Expert Panel Assessing ATSDR's Methods and Analyses for Historical Reconstruction of Groundwater Resources and Distribution of Drinking Water at Hadnot Point, Holcomb Boulevard, and Vicinity, U.S. Marine Corps Base Camp Lejeune, North Carolina

April 29-30, 2009

Edited by: Morris L. Maslia

Figure 6. Location of interconnections between Hadnot Point and Holcomb Boulevard water-distribution systems, U.S. Marine Corps Base Camp Lejeune, North Carolina.

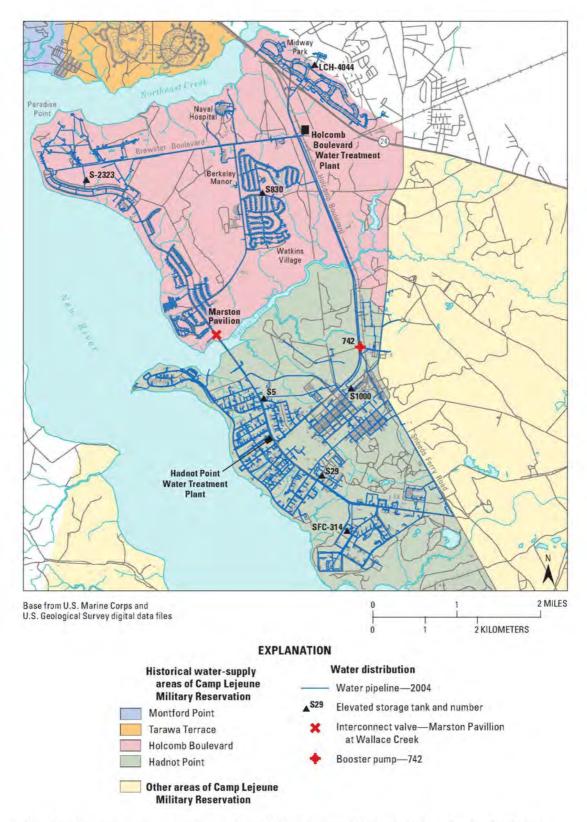
Mr. Harding asked for clarification on whether the Wallace Creek (Marston Pavilion) valve was open at the same time that booster pump 742 (Figure 6) was used, indicating that water would be expected to flow back to Hadnot Point if the valve had been open. Mr. Maslia commented that the understanding is that the valve was open if there was insufficient flow from the booster pump. Joel Hartsoe of the Camp Lejeune Public Works Department noted that only the valve was open. Mr. Maslia explained that information about the valve being open was based on log book entries; no record was found explaining why the valve was open.

Dr. Grayman suggested charting the booster pump and the number of hours that the valve was open. He also noted that ATSDR should consider the stochasticity at the treatment plant in terms of when the booster pump was on; suggesting that a probabilistic analysis be done for the source contributions. Dr. Harding agreed, noting that the time of day was absolutely critical as well as determining whether the tank was full or empty. Mr. Maslia explained that ATSDR would not be able to complete such complex analysis because they have no time data. They do, however, have detailed concentration data associated with the January 1985 event when BTEX-contaminated finished drinking water from Hadnot Point got into the water-distribution system at Holcomb Boulevard. Data include daily records
